MEMORANDUM

TO: Water Right File 65-22945

SUBJECT: Licensing Review of Water Right 65-22945

FIG. 1.

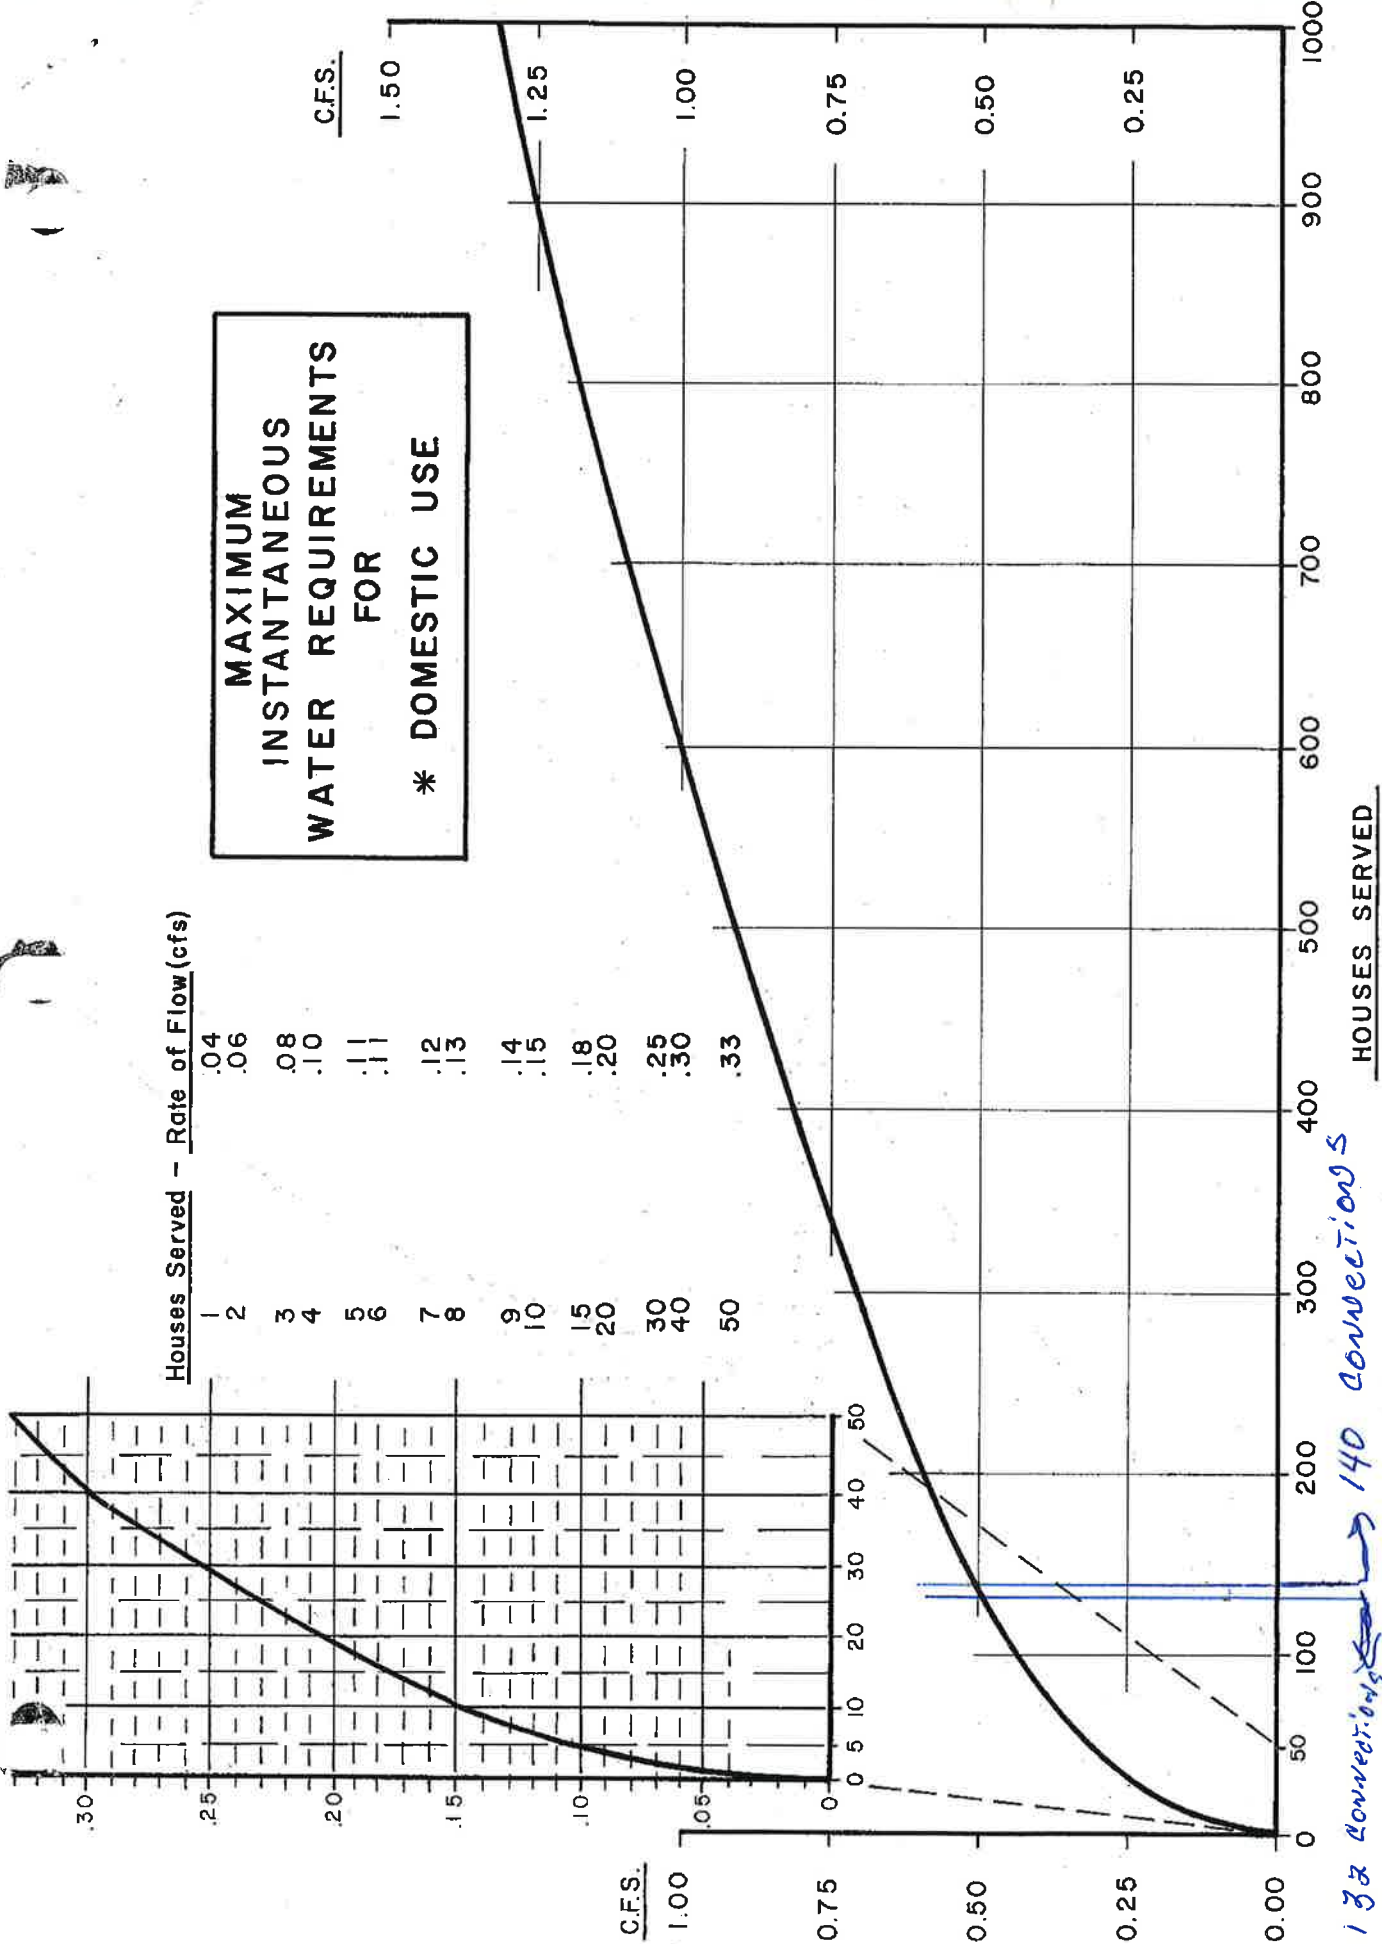
In the October 1, 2019, email, Ms. Pape determined that there was actually 140 connections instead of the 132 recommended in the field report. Using the charts used by Mr. Scanlan that is part of Administrative Processing Memorandum #22, I determined the diversion rate will actually not change. The difference of 8 domestic connections does not register on this chart.

Using the theoretical calculation, I am recommending that this permit be licensed for 0.50 cfs for domestic use, 0.21 cfs for irrigation ($10.4 \text{ acres} \times 0.02 \text{ cfs/acre} = 0.208 \text{ cfs}$), and 3.34 cfs for fire protection for a total diversion rate of 4.02 cfs. No combined limitation conditions are needed.
